CLIMATE CONTROL—ERRATIC OPERATION OF THE COOL/WARM FUNCTION OF THE TEMPERATURE CONTROL SYSTEM—REPAIR PROCEDURE FOR STRATIFICATION (SECONDARY) TEMPERATURE BLEND DOOR

Article No.
02-23-6

FORD: 1996-2003 TAURUS

Figure 1 - Article 02-23-6

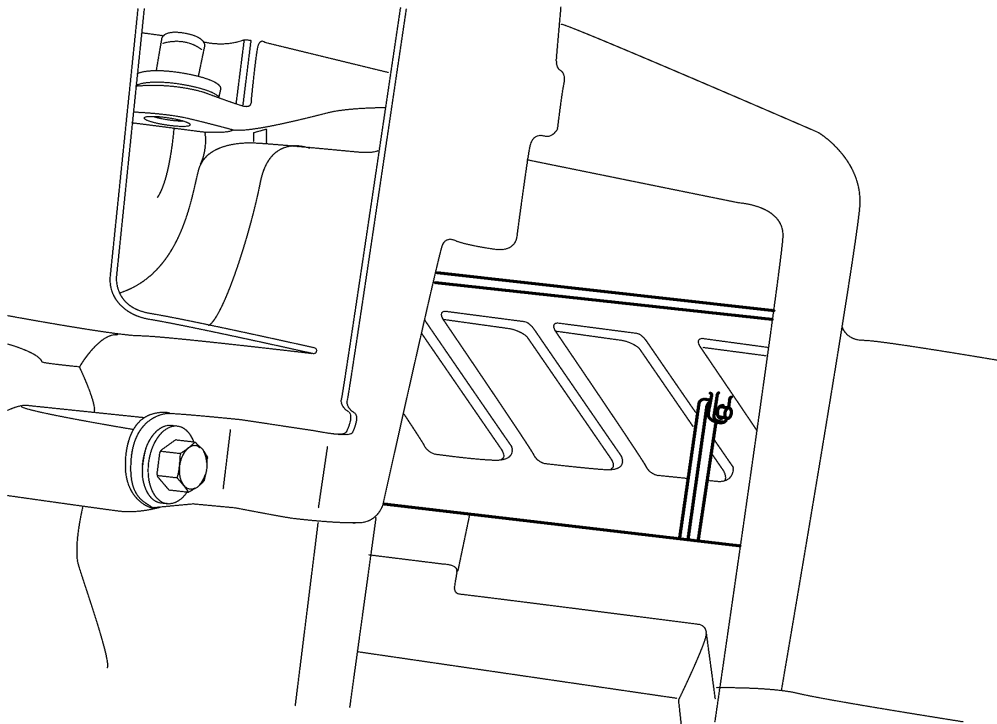
4. Inside the plenum, you will see the Stratification (Secondary) Temperature Blend Door or upper door attached to the main temperature blend door by an internal white nylon link. Disconnect the nylon link from the stratification door. Squeezing the clips together on the white nylon link should aid in removal (Figure 1).

5. Reach inside and remove the stratification door. Cutting the door with metal snip pliers near the pivots will provide easier removal.
6. Place the new door 3F1Z-19D842-AA inside the plenum chamber and slide in the large pivot point first (which is closest to you) then slide the door into position until the small door pivot point on the front side of the case clicks into place.
